Is the New Devil's Slide Trail Safe?

Subject: San Mateo County Parks – Response to 2013-14 Grand Jury Report "Is the

New Devil's Slide Trail Safe?"

View of current fencing designed to prevent access to Bunker Hill

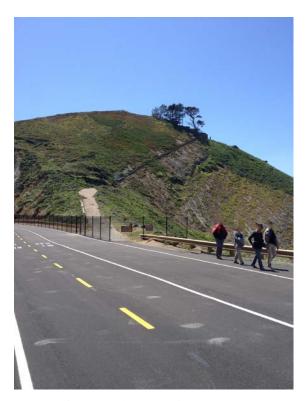
Authorities anticipate that the Trail, as part of the California Coastal Trail, will be a popular destination not only with Bay Area residents but also with out-of-state visitors. Of particular interest in this area is Bunker Hill, a WWII gun emplacement, which is situated on the west side of the Trail and accessible by an old, unsafe, dirt, stairway lacking handrails and any maintenance. Until recently, the area has been used by local firefighting organizations as a fire spotter look-out. The area is now restricted and there is cautionary signage so indicating. The Grand Jury toured the Trail and, based on its observation, it believes that the current fence allows easy unauthorized access to the old staircase. Evidence of trespassing was noticeable to the

Grand Jury prior to the Trail's official opening. Based on its observation of the Trail and discussion with Parks officials, the Grand Jury believes clearly indicate the current fencing does not prevent people from gaining access to the staircase.

- F1. The Trail does not have an emergency call box and cell phone service on or near the Trail is unreliable.
- F2. At times, there will be no park ranger present to respond to an emergency on the Trail.
- F3. The Trail is not suitable for simultaneous mixed-use by horses, dogs and hikers.
- F4. Sections of the existing fencing inadequately prevent unauthorized access to Bunker Hill.
- F5. The guardrailed sections of the Trail do not prevent children from accessing the cliffs.

Subsequent to the opening of the trail, County Parks contracted to have additional fencing placed on the north corner of Bunker Hill to prevent people swinging around the end of the fence, and additional cross-fencing was added. Moreover, additional warning and regulatory signs were placed at Bunker Hill.

While County Parks has already implemented this recommendation, staff will continue to look at options for improving the fence.

Guardrailed section

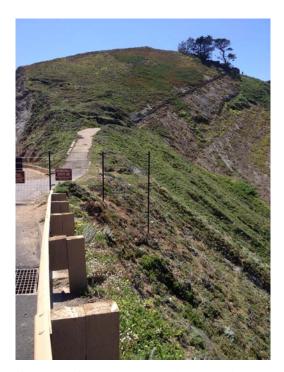
Additionally, the cliff area adjacent to the fence has a guardrail -- as opposed to "K-rail" utilized on the majority of the Trail – which is large enough for children to crawl under it and fall down the cliff. Although originally designated for K-rail, park officials indicated that existing guardrail was used as a cost saving measure in this area.

The terrain directly west of the guardrail falls sharply downhill to the ocean. Adding a section of fence running north and south, beginning at the southwest end of the current fence (so as to prevent any restriction of the view) and ending at the interpretive center north of the guardrailed section, would both prevent access to the Bunker Hill staircase and help to prevent serious falling accidents in this area.

The existing guardrails are a common feature on trails and roads. In the case of Devil's Slide Trail, the task force considered a variety of factors in selecting barriers and fencing including: safety, cost, aesthetics, viewing areas, durability in the elements and visually screening people from birds nesting on rocks. A balance was struck among competing variables. All outdoor recreation settings present inherent risks which parents and others need to keep in mind.

Simply replacing guardrail with K-rail may not be the best alternative to reduce the risk while at the same time maintaining the aesthetics of the trail and view. By December 31, 2014, County Parks staff will determine the best options to meet multiple objectives for the trail and begin implementation to address the Grand Jury's concerns.
